**SAN ANTONIO WATER SYSTEM**  
**WATER PRODUCTION FACILITIES DISINFECTION SYSTEM UPGRADES PROJECT**  
**SAWS Job No. 12-6004**  
**SAWS Solicitation No. B-14-042-DD**

**ADDENDUM NO. 2**  
**August 7, 2014**

SHEET: C-16  
20 OF 125

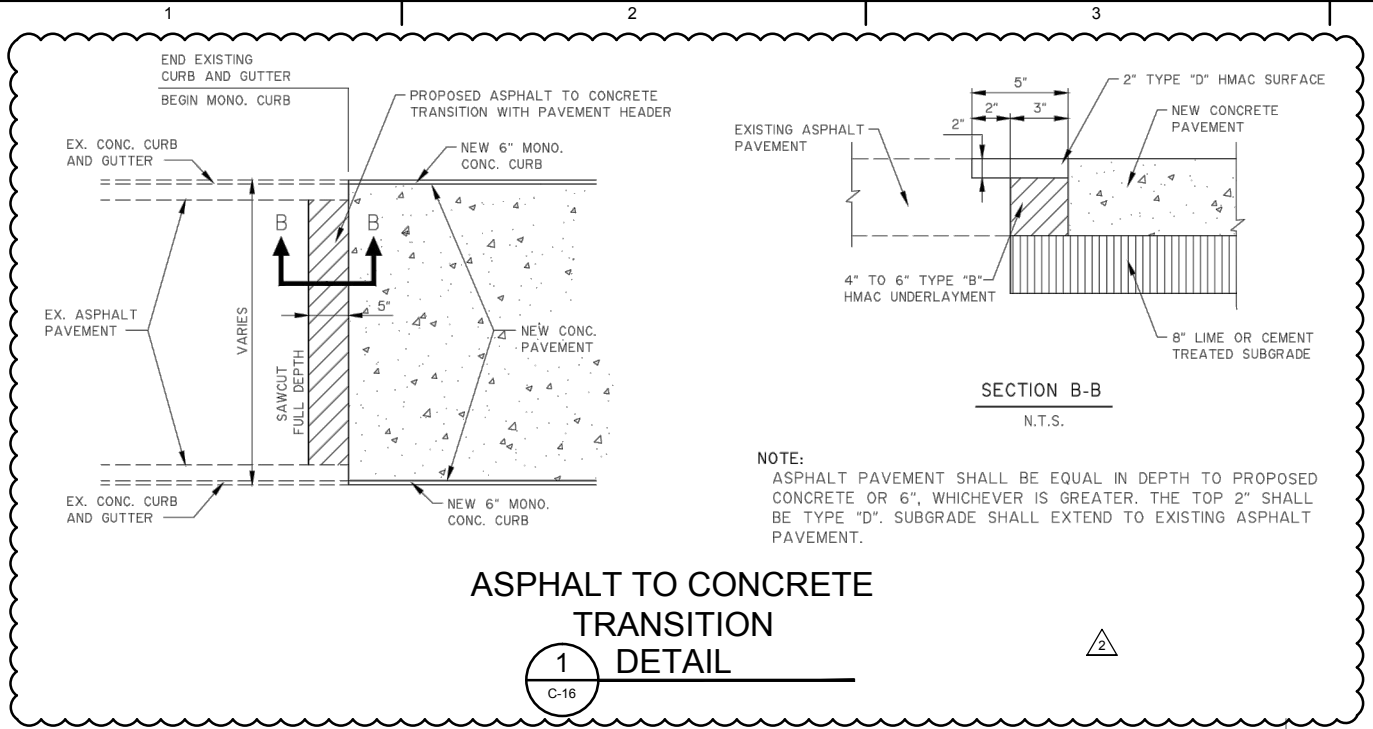
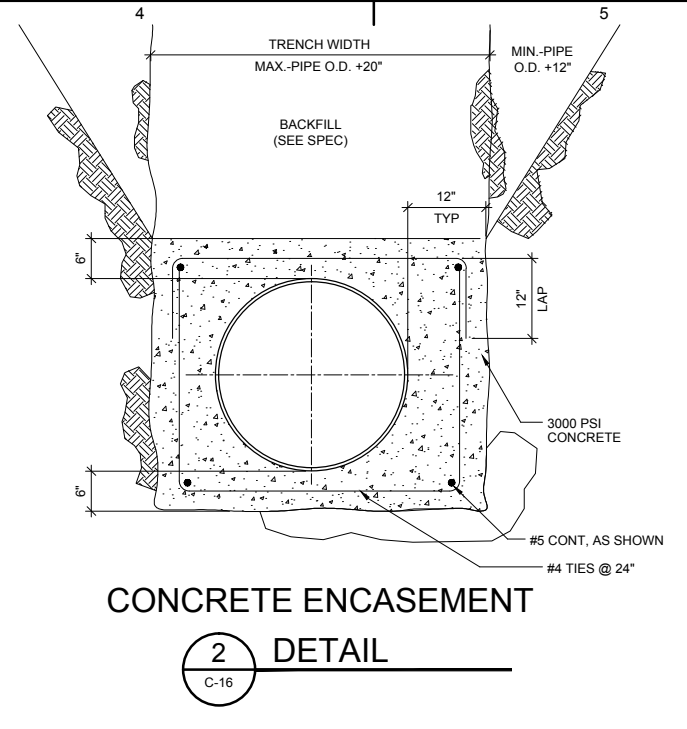
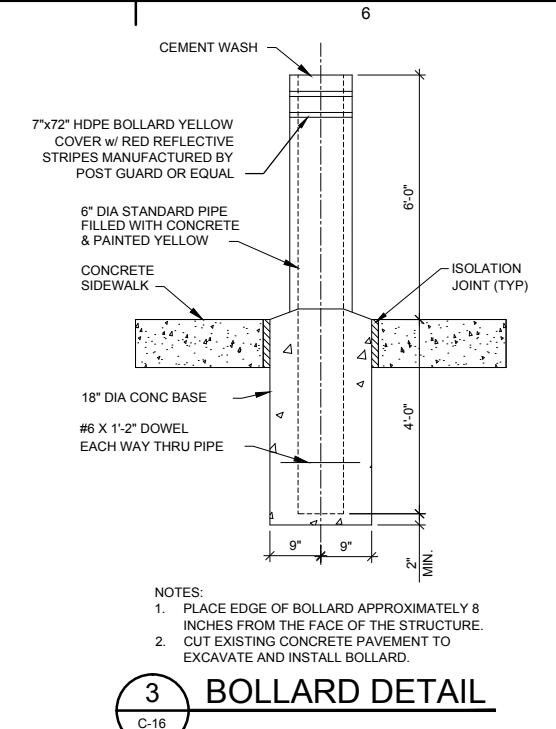
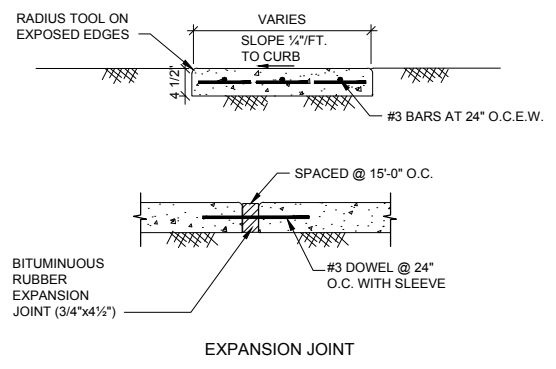
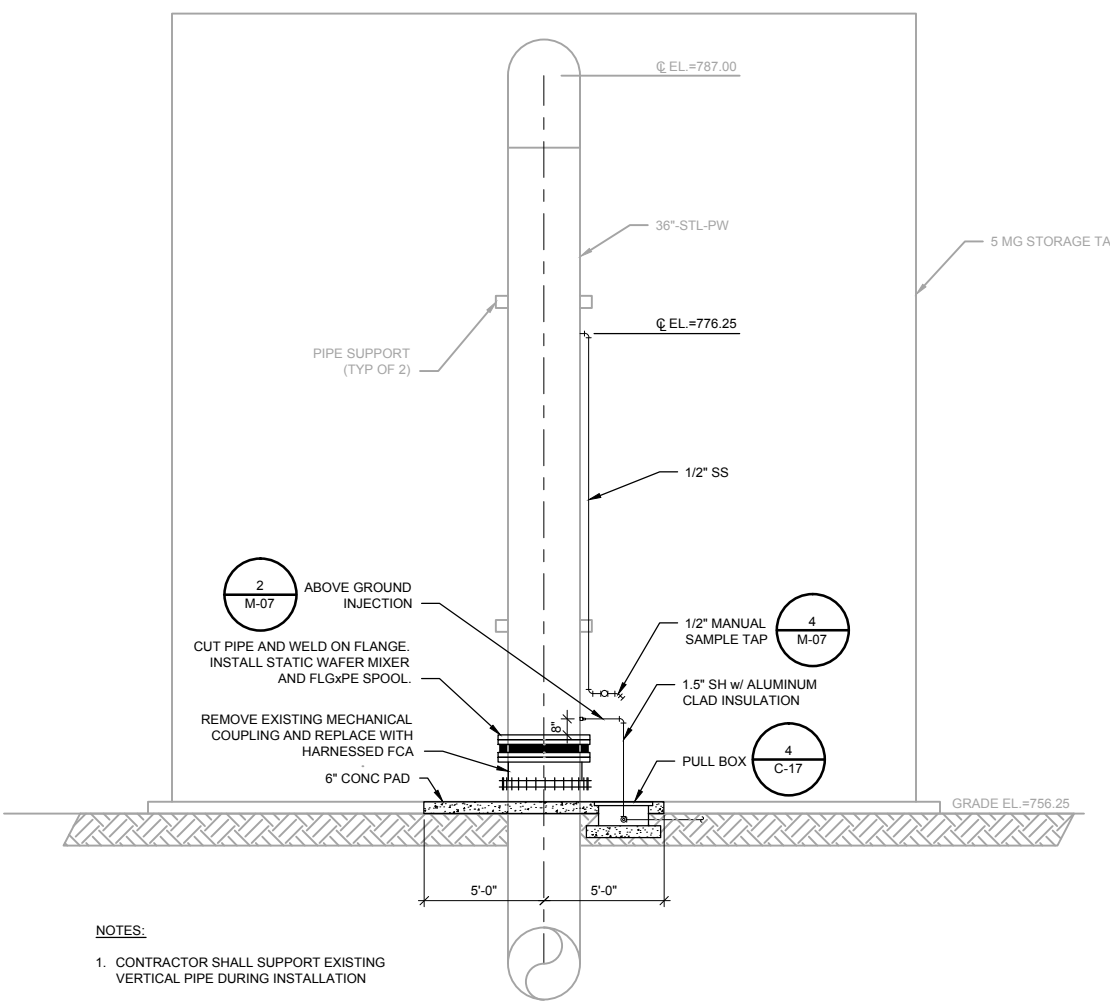
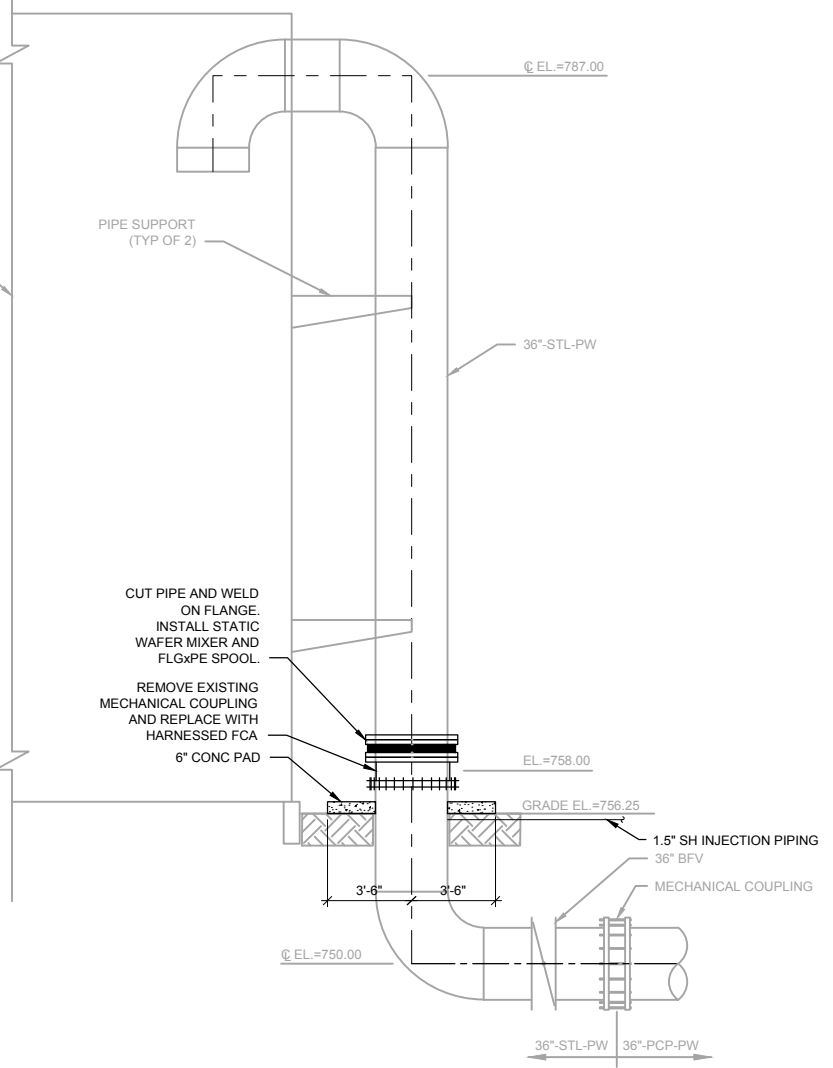
**8. Sheets C-16**

- a. Add concrete pavement detail

SHEET **M-01**  
27 OF 125

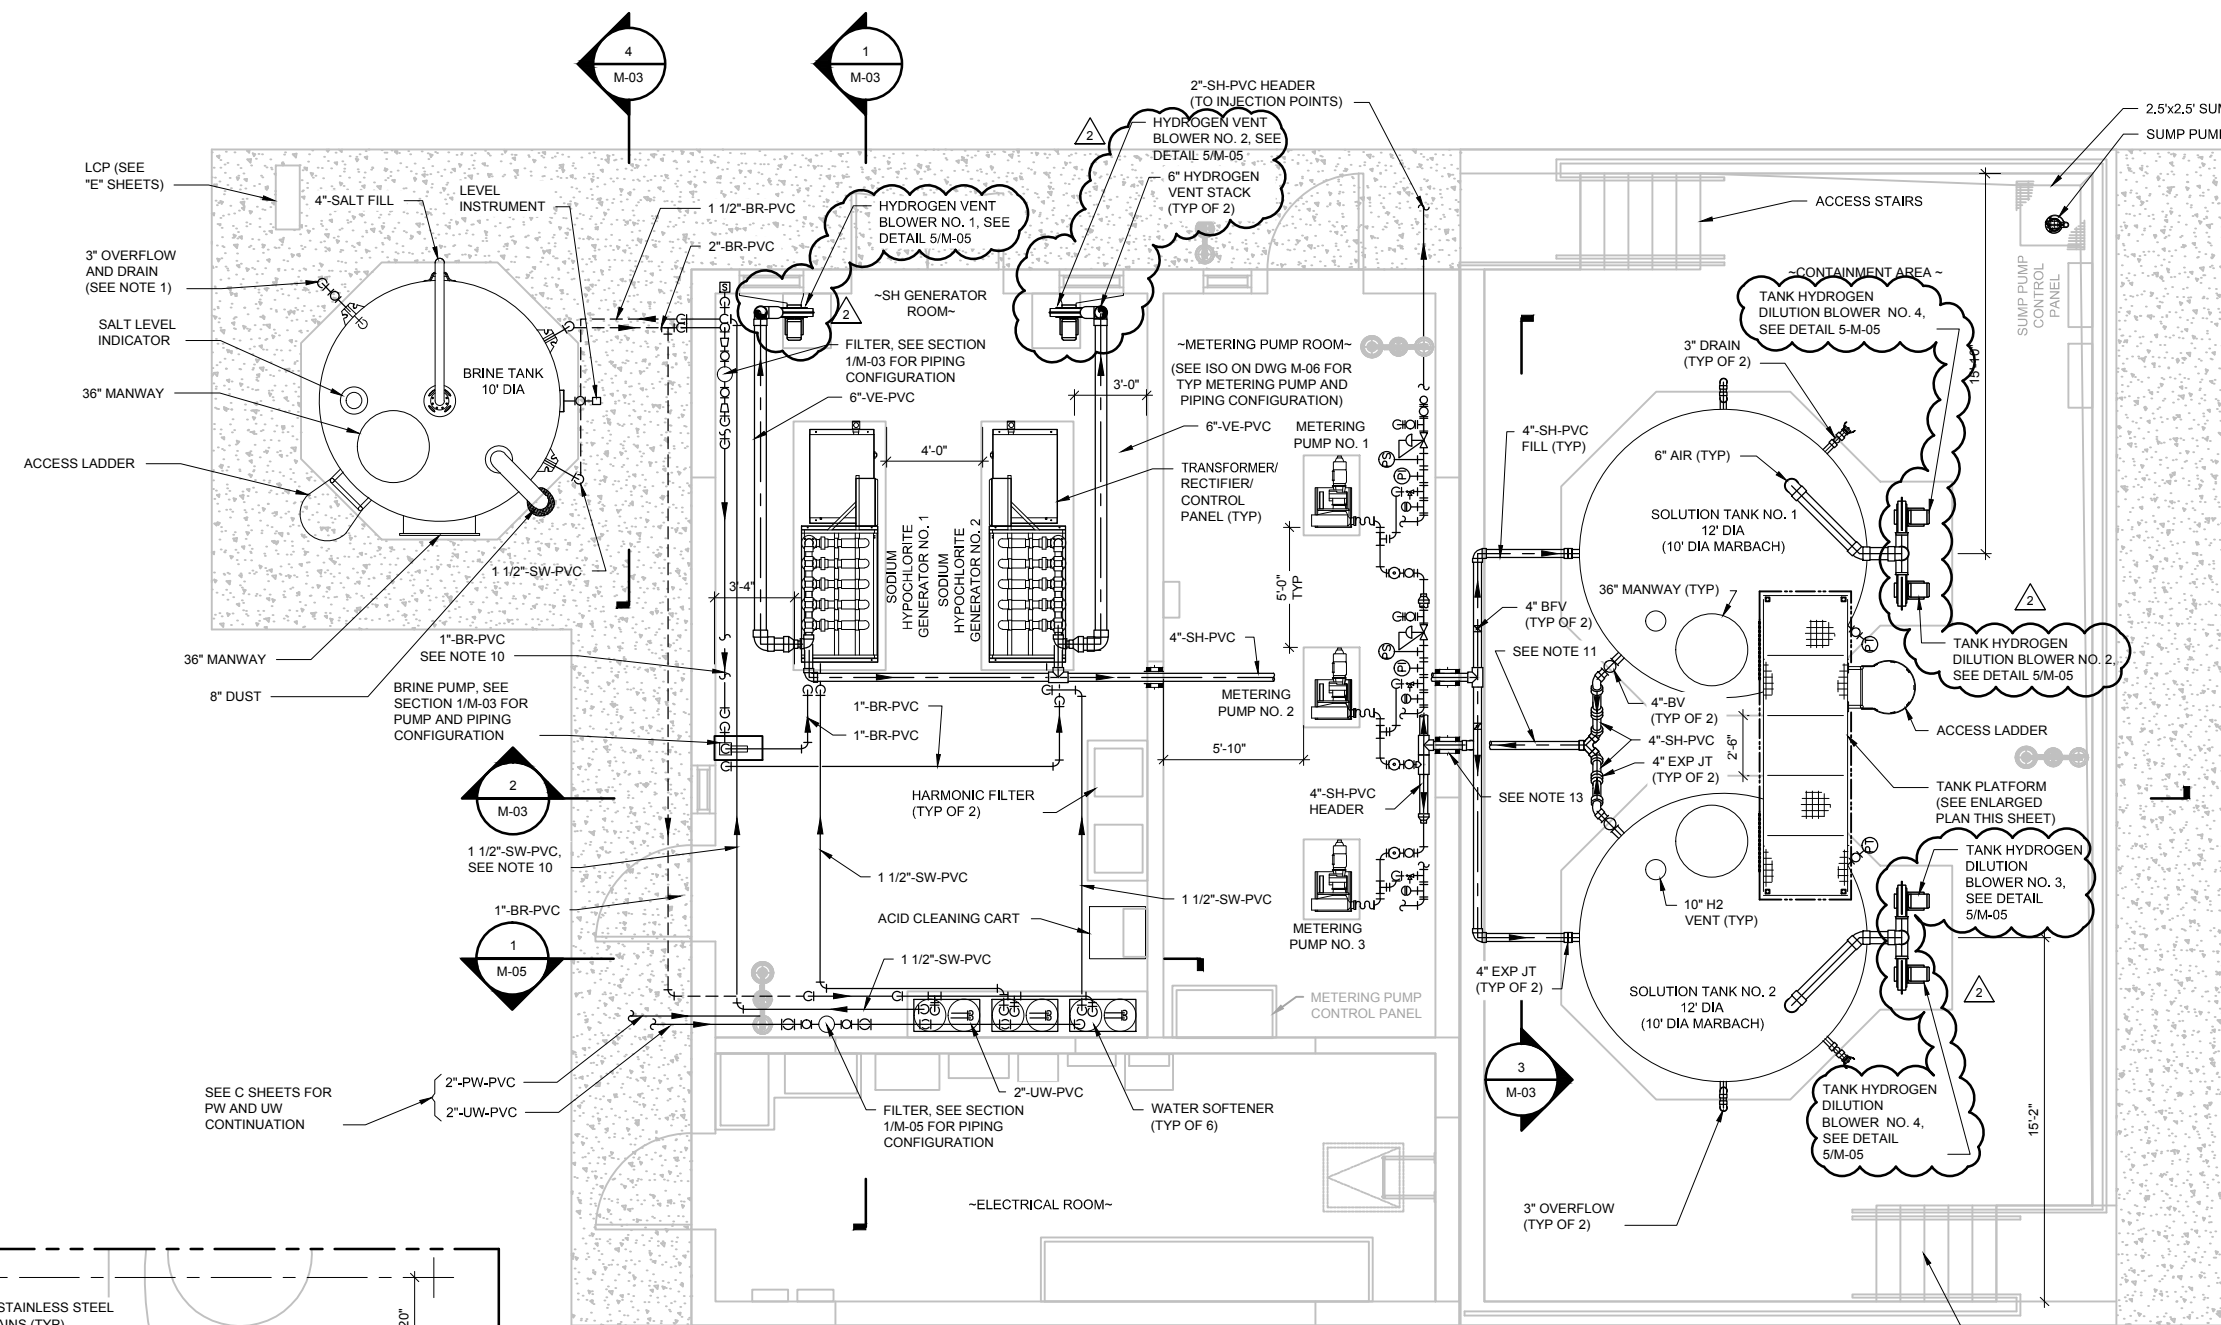
**10. Sheets M-01 and M-02**

- a. Update blower layout

SHEET **M-03**  
29 OF 125

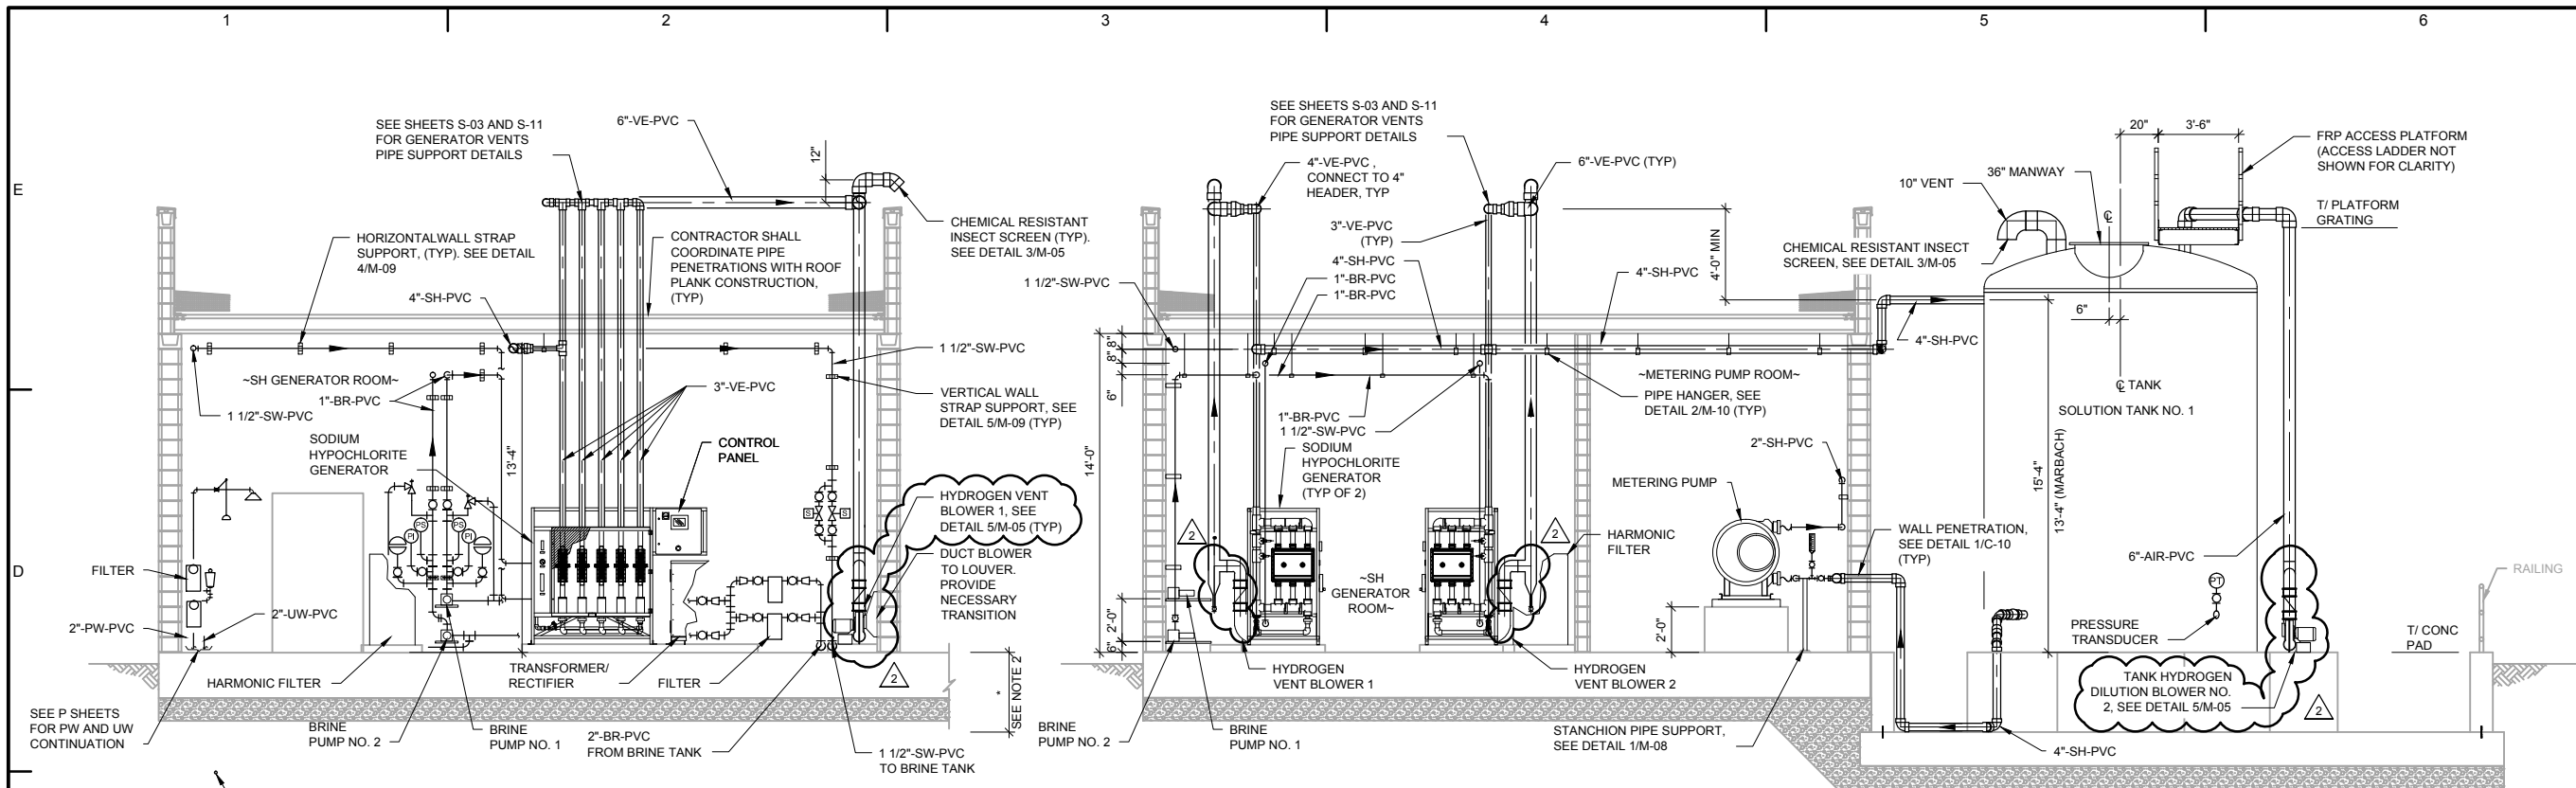
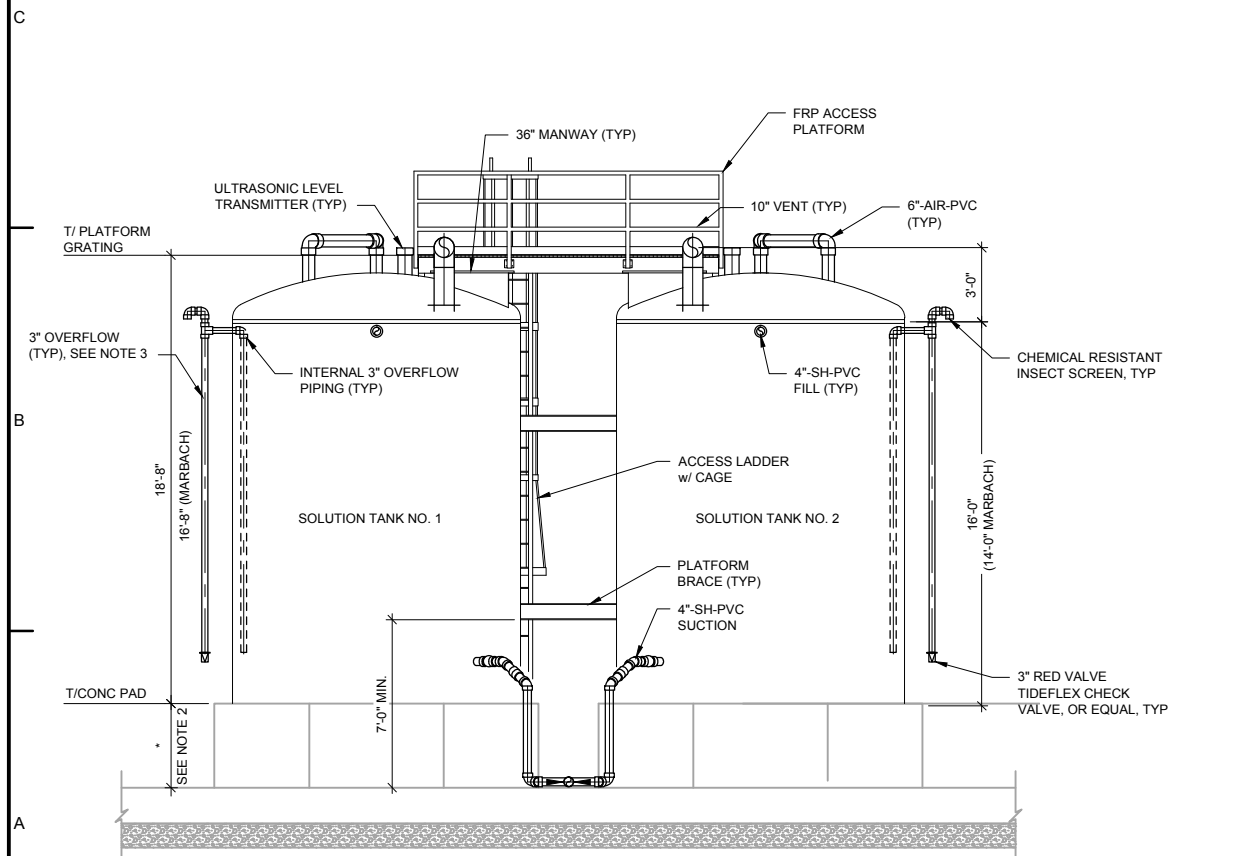
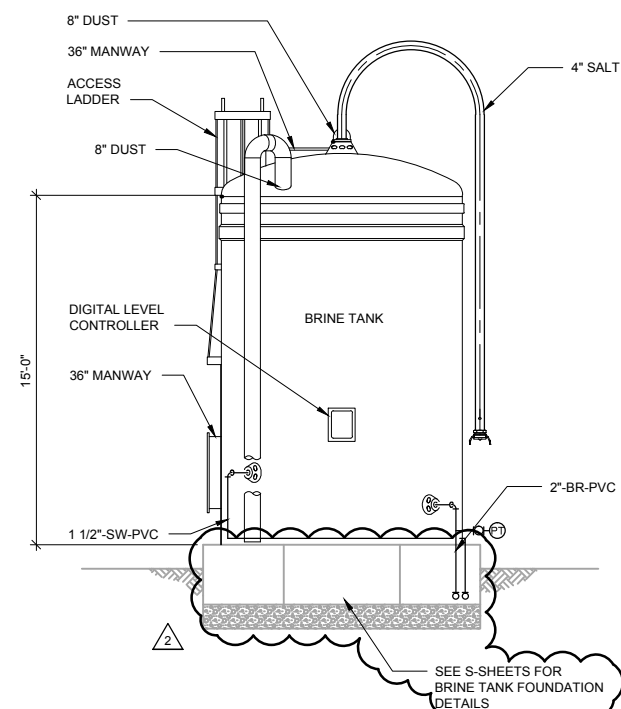
**11. Sheets M-03 and M-04**

- a. Brine tank foundation callouts have been updated to match Structural sheets
- b. Update blower layout
